MMT104-NX21D is not available

Replacement is Contactor003 (Contactor043 Allen Bradley 100-C16*10B).

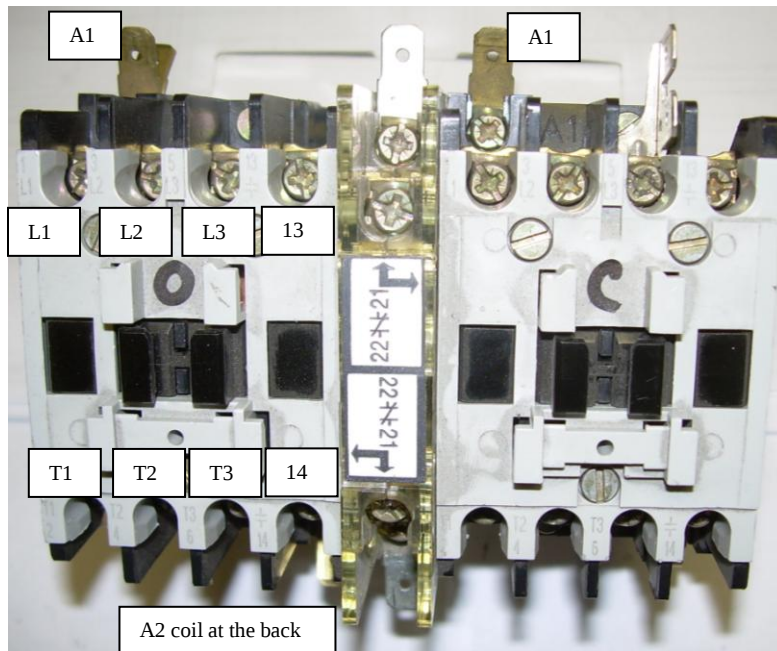
2- MMT contactor to be replaced.

3- Allen Bradley Contactor043 to be used.

1- See Drawing013 for 1 Phase or 3 Phase, available on www.Manaras.com at Technical Documents\Miscellaneous Technical Documents.
